Device **C515C-8R,
C515C-L**

Marking/Step **Step AA**

Package **P-MQFP-80**

This Errata Sheet describes the deviations from the current user documentation. The module oriented classification and numbering system uses an ascending sequence over several derivatives, including already solved deviations. So gaps inside this enumeration can occur.

CAN.4: Flowchart sequence in figure in User's Manual regarding Micro-controller handling of the Last Message Object is partly incorrect

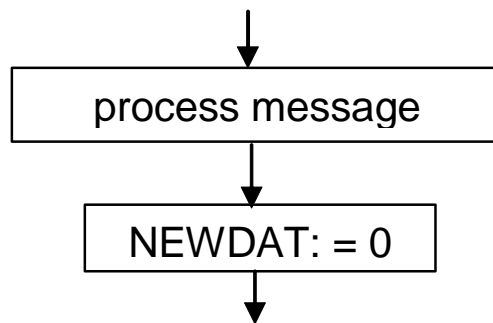
For the software flowchart figure 6-48 in User's Manual 11.97, the correct would be to first 'process message contents' and then to 'clear bit NEWDAT'.

This correction will be updated to the future versions of the User's Manuals.
